A-580203

664 A
 TYPE TEL SET
 CONNECTING
 DIAGRAM

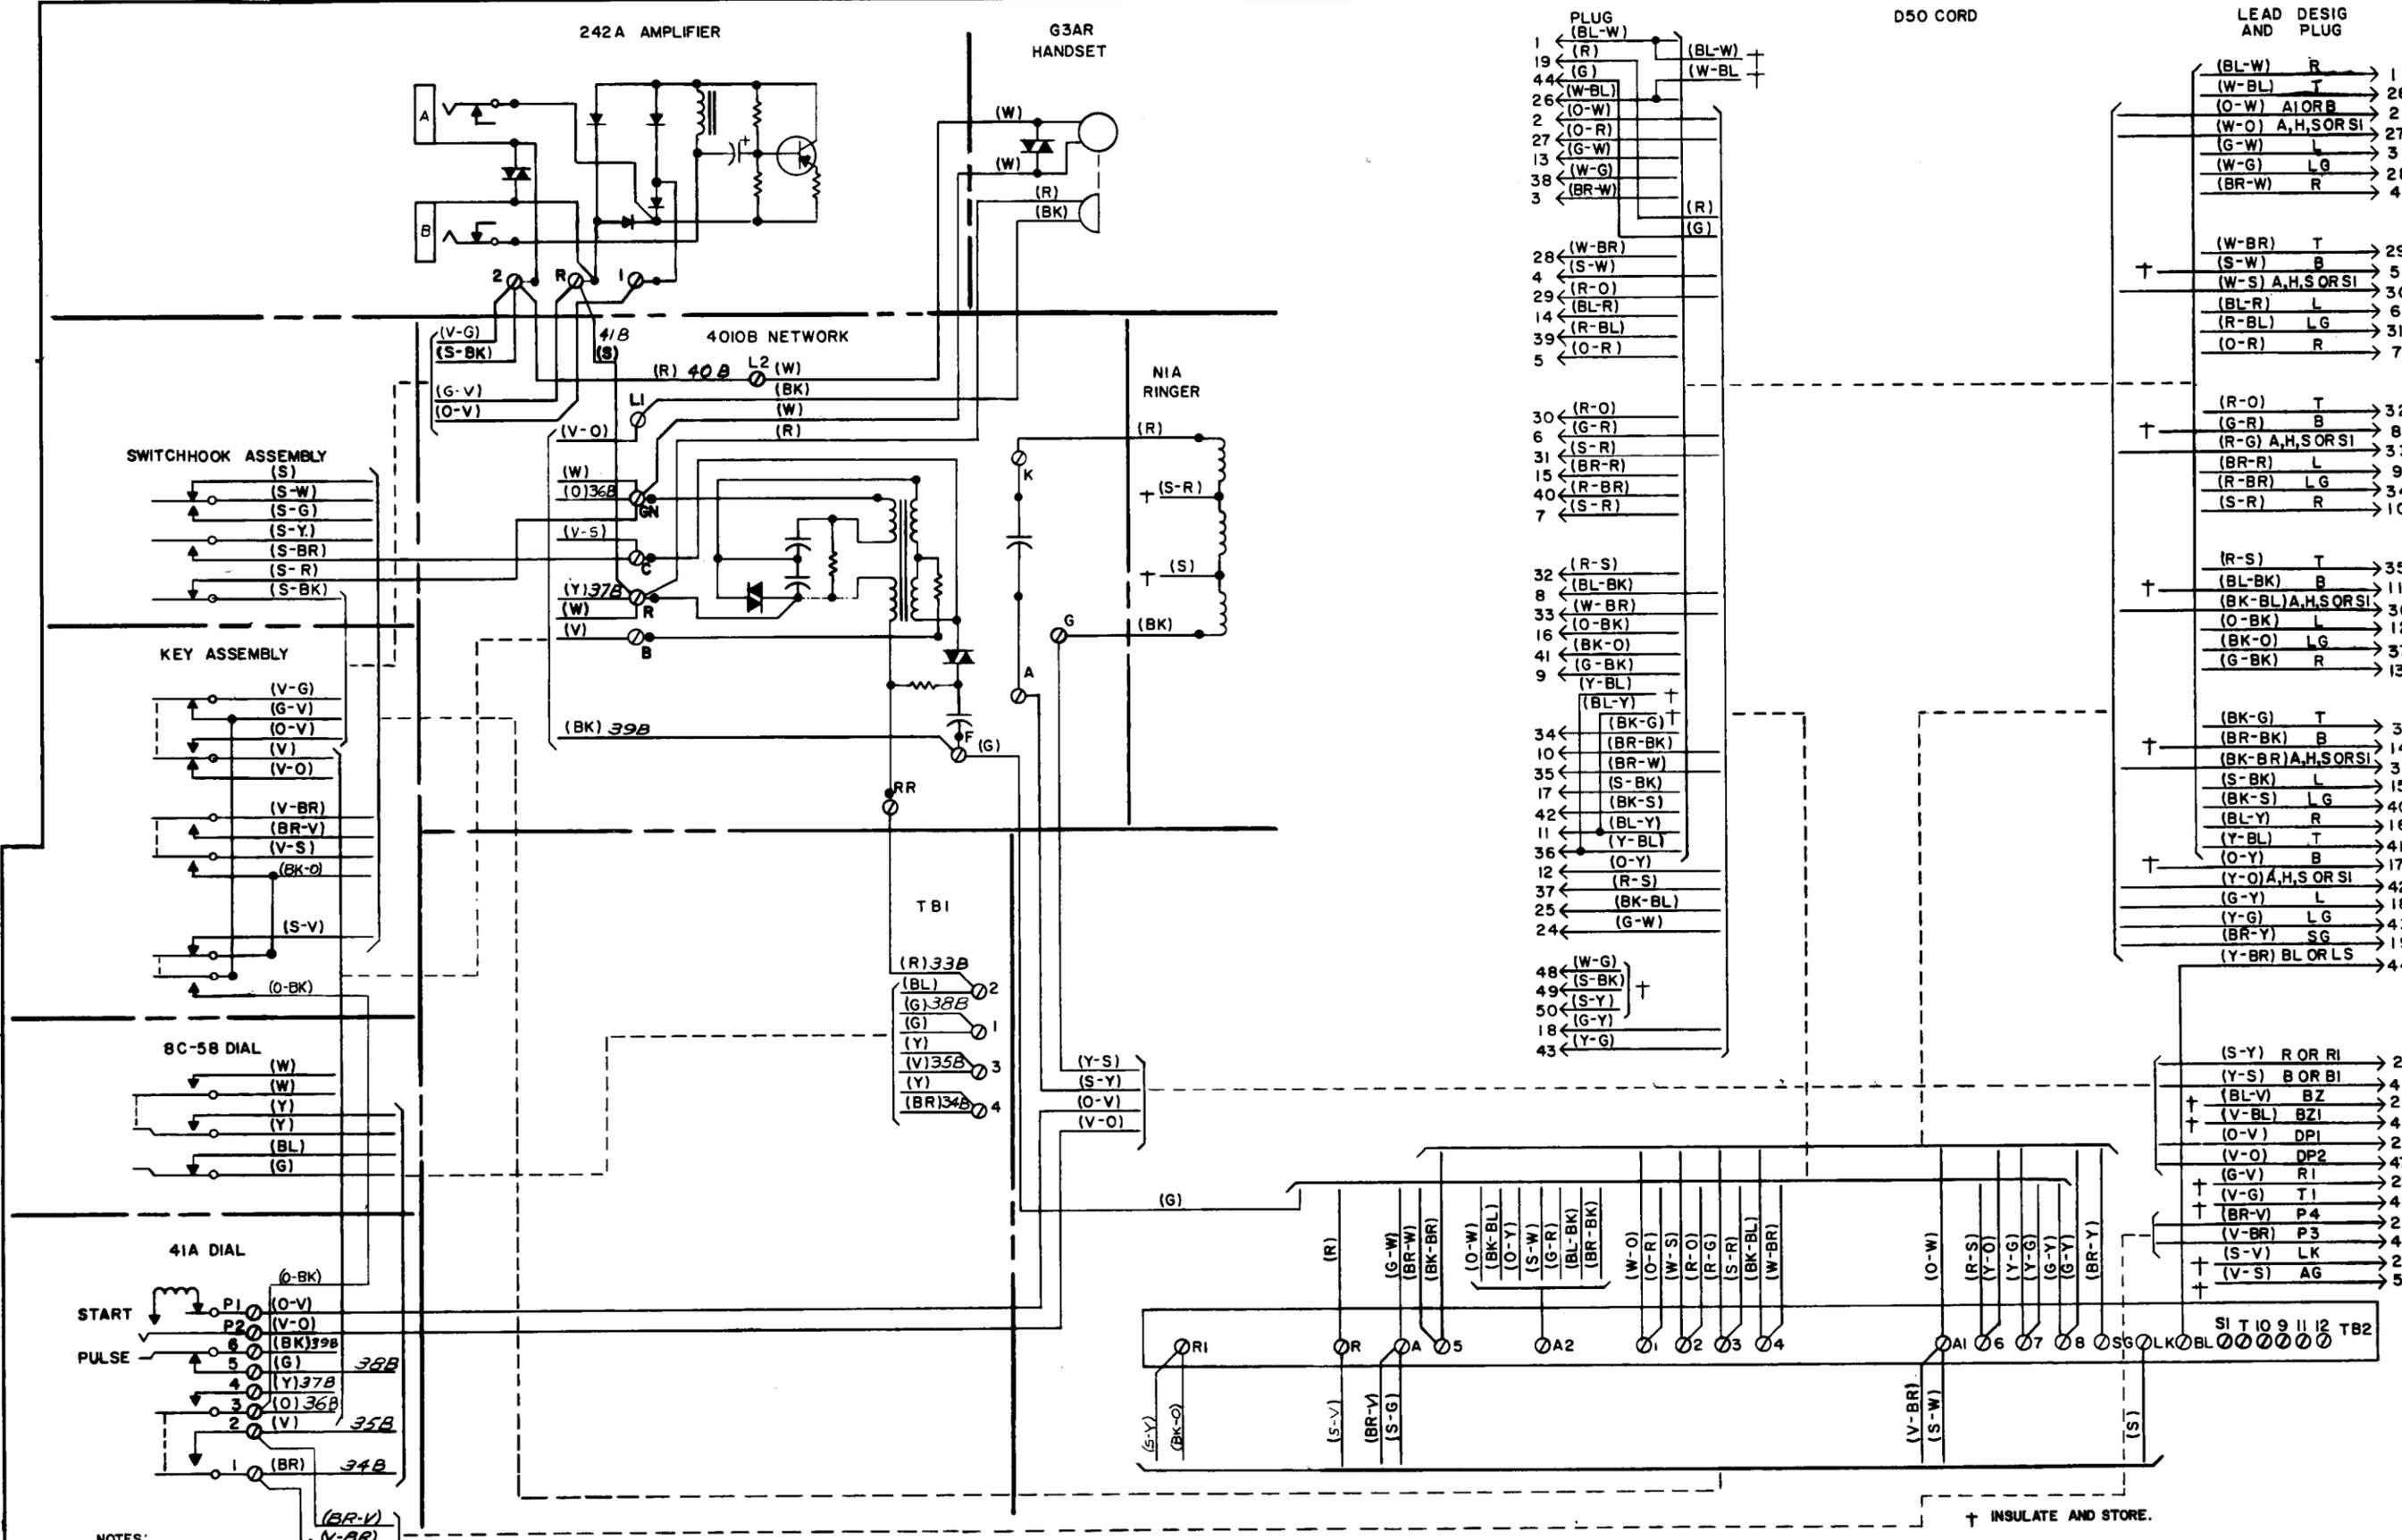
REV. 11/64
 C. J. ENGLISH
 7-2-64
 1808 1/L
 8-5-63
 1334-1
 ADDED TO BRG/ALGUS TO KEY ASSEM.
 REMOVED: STRAP WIRE FROM KEY ASSEM. BETWEEN (V-G) LEAD CONNECTION & BOTTOM CONTACT
 CHANGED: (S-V) & (Y-G) LEADS CONN. TO 242A AMP WERE INTERCHANGED; (Y-S) & (S-V) 4000 B NET & TERM R OF TB2 RES HERE INTERCHANGED; (S-Y) LEAD TO TERM RI OF TB2 WAS CONN TO TERM R OF TB2
 L. REED 443651-AIC
 8-5-64
